Architectural and Urban Design Review

**prepared by
BHI Architects**

**Various Allotments
Terralong, Akuna and Shoalhaven Streets
Kiama**

100 TERRALONG STREET, 3 AKUNA STREET, 55 SHOALHAVEN STREET, 61
SHOALHAVEN STREET, KIAMA – ADM ARCHITECTS
DA10.2016.304.1

(i) Delete level 4 from building D and E and replace with communal open space to achieve height compliance on this building and closer compliance to the overall communal open space requirements.

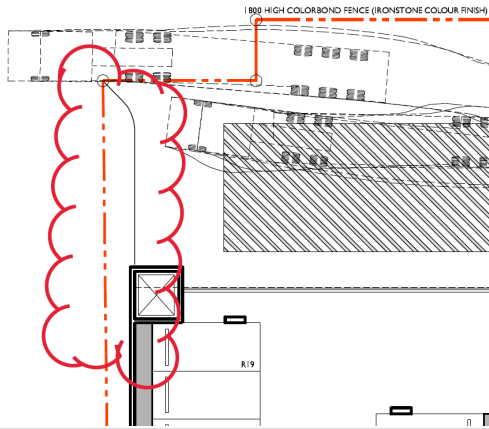
BHI NOTES	BHI REVIEW (ISSUE Z, SEP 2018)	✓ / ✗
<ul style="list-style-type: none"> The communal open space provision across the site was deemed to be insufficient, and proximity to Hindmarsh Park was not deemed to satisfy the ADG requirements for the site. 	<ul style="list-style-type: none"> Additional communal open space on the roof and upper levels of buildings has resulted in a compliant 1968m²/25% communal open space. 	✓
<ul style="list-style-type: none"> The JRPP identified that the height exceedance in this location was significant and therefore unsupportable. Given the longer street frontage of this building, the additional bulk also had a greater impact than other buildings within the site. The recommendation to resolve these items simultaneously is to remove level 4 from this building and replace it with communal open space. 	<ul style="list-style-type: none"> Height compliance has not been achieved despite removal of level 4 and replacement with communal open space. This is due to raising the residential floor levels by 1m to reduce the height difference between the Level 1 apartments and the streetscape, which improves resident amenity and allows greater activation of the Akuna Street frontage. The overall height and perceived bulk from Akuna Street has been reduced. Components of the building above the height plane fronting Akuna Street are the building core and planter boxes, which are necessary components of the communal open space. BHI believes the height exceedance is justified in this position due to the above. 	Justified
